NONCONFORMANCE REPORT

Project No. 20-01402-571

NCR No. 2002-08

One of the Alloy 22 weld qualification specimens CNWRA Drawing 20-01402-571-025 machined by Texas Toolmakers was not machined correctly. A detailed description of the non conformance items is provided below:

Alloy 22 Rod Specimen
CNWRA Drawing 20-01402-571-25
All Dimensions $\pm 0.010"$
unless otherwise specified
Note: Detail A on Page 2

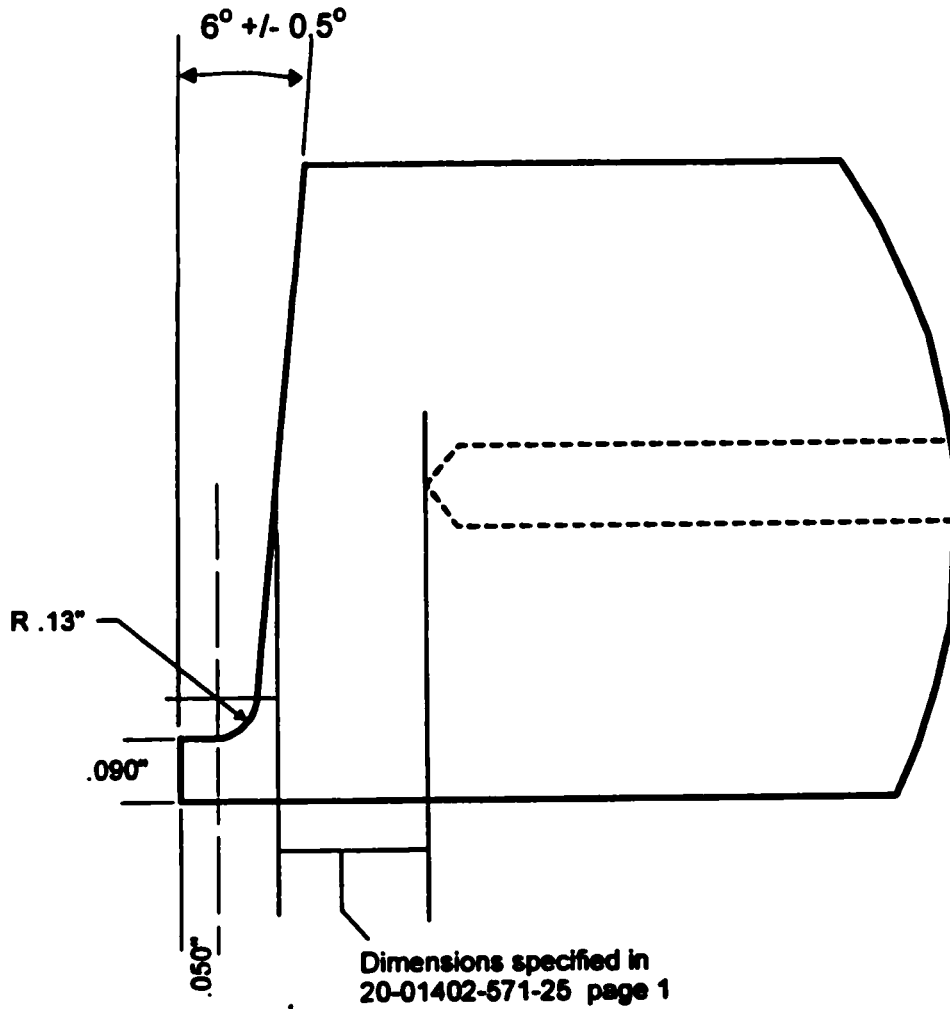
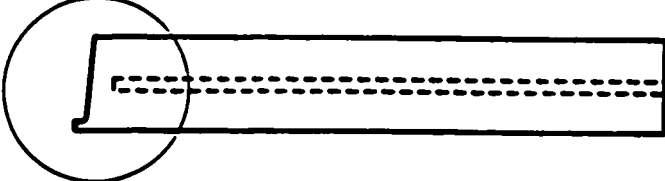
- 1. All plates: The 1.00 inch dimension (plate thickness) was not machined. Thickness of machined specimens was left as the nominal plate thickness.
- 2. Plate S/N 003: The 0.250 inch dimension was not recorded on the dimensional inspection for plate S/N 003.
- 3. Plate S/N 006: Thermocouple bore was machined too deep and has nearly penetrated through the weld joint surface.

Item #1: Plate thickness is not normally not machined for this type of specimen. Corrections to CNWRA Drawing 20-01402-571-25 are recommended. The 1.00 +/- 0.010 inch dimension for plate thickness should be changed to 1 inch nominal thickness.

The missing dimensional inspection for the 0.250 inch dimension on plate S/N 003 (diameter of thermocouple hole) is an oversight during the dimensional inspection of this part. The nominal plate thickness which is slightly greater than 1.00 inch is acceptable for the weld procedure qualification specimens. Plate S/N 006 was rejected on the basis of the incorrectly machined thermocouple bore. Repair of weld procedure qualification specimen S/N 006 will be performed if needed and all dimensions will be reinspected and documented.

Item #3: No corrective action will be taken at this time. Plate will be tagged indicating out of tolerance dimensions. If weld procedure qualification specimen S/N 006 is used, it will be repaired and re machined. All repair work will be performed at SwRI or a vendor on the SwRI Approved Supplier List and documented.

8/28/22
All P/plates Accepted AS is no corrective action required for nominal thickness of 1 inch ^{plate} and plate 51006 tagged as being out of tolerance and will require repair work prior to use. The 0.250" hole diameter verified by SWR1 QA staff see attached drawing.

all plates accepted as is with the exception of 006. ~~Matrix~~ If plate 006 is used it will require repair. If not used no further action is required. The hole for plate 003 was measured by the S&T inspector and found to be acceptable.

Alloy 22 Specimen
 CNwRA Drawing 20-01402-571-25
 All Dimensions $\pm 0.010"$
 unless otherwise specified
 Note: Detail A on Page 2

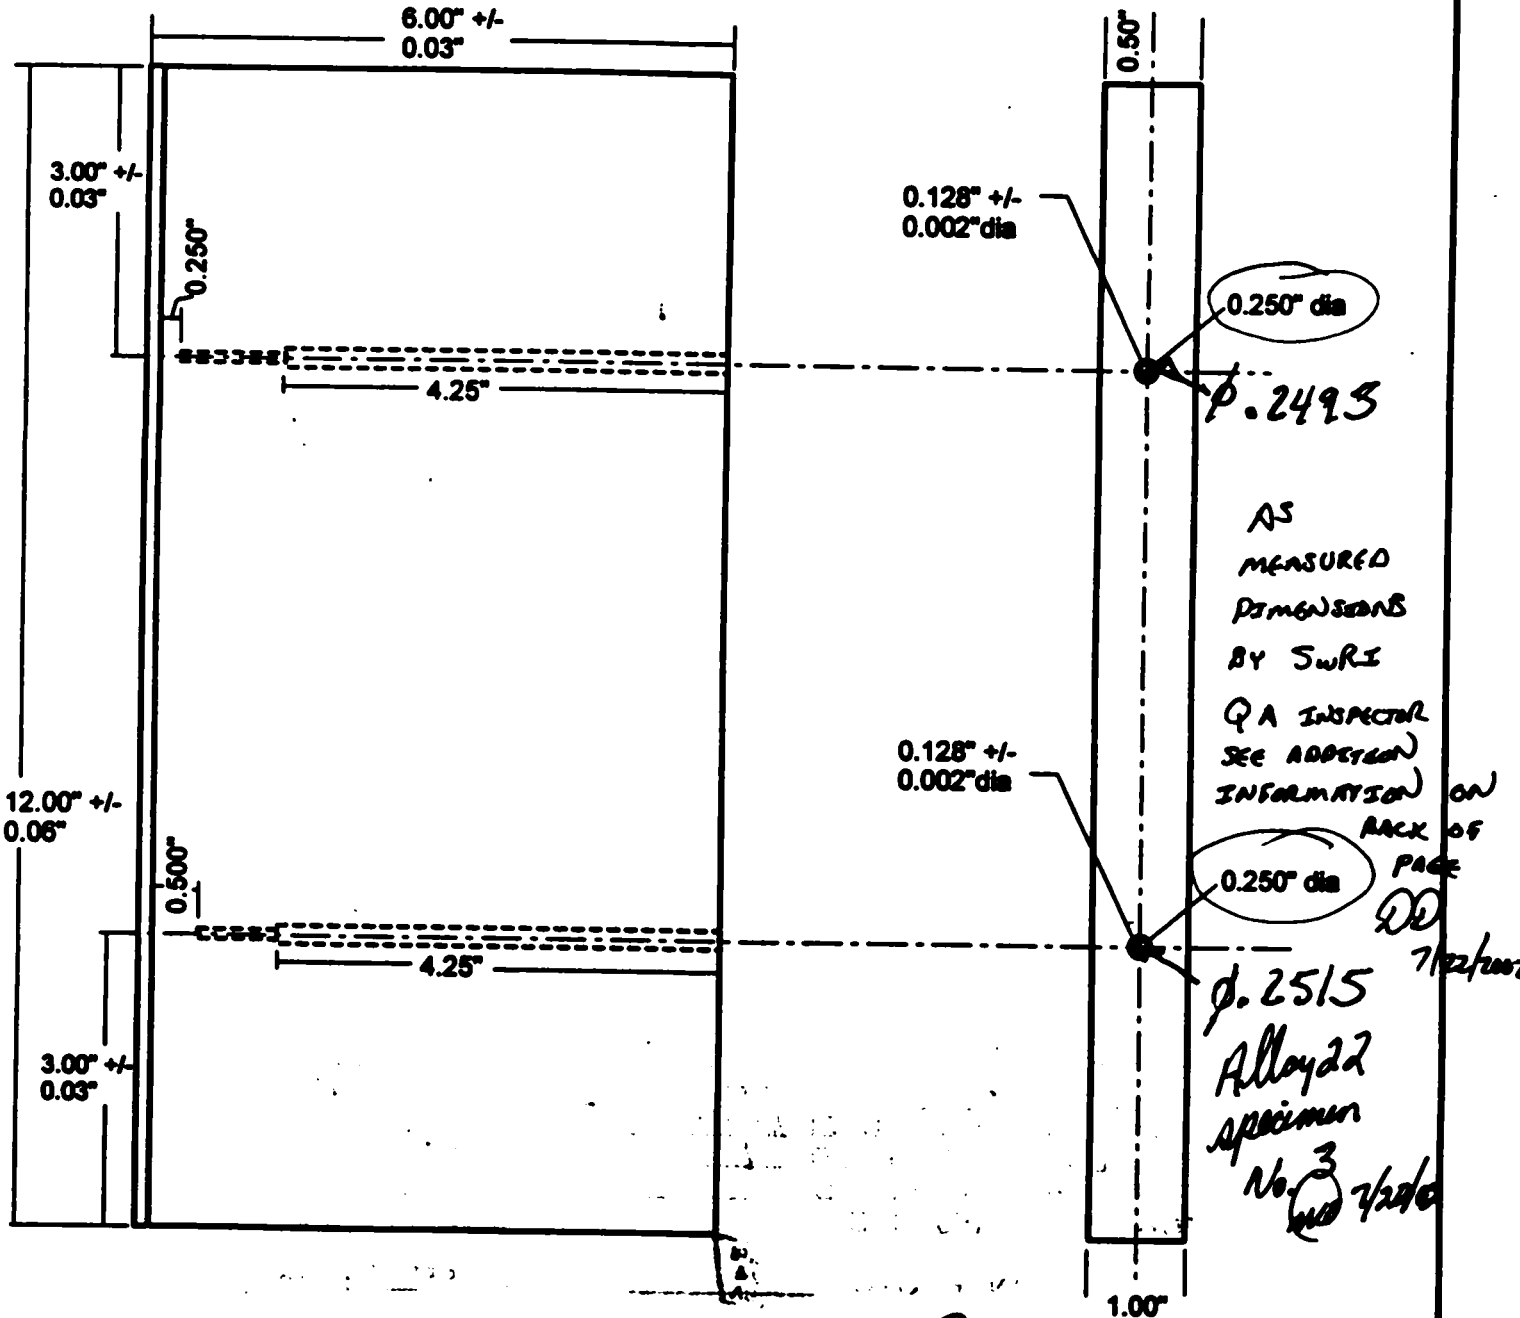
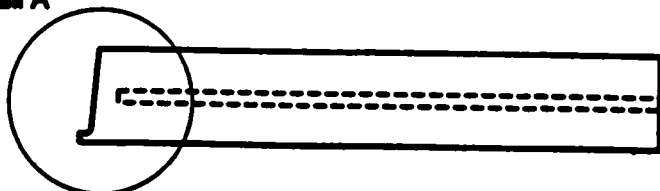
Item #2: The 0.250" hole diameter will be verified by SwRI staff and documented on dimensional inspection for Plate S/N. 003. *7/17/2002*

Item No. 2 on the NCR, examination of a 0.250-inch hole, has been performed and is acceptable. Item No. 1, drawing revision has not been performed but is not a quality-affecting hold point for close out of NCR 2002-08 .
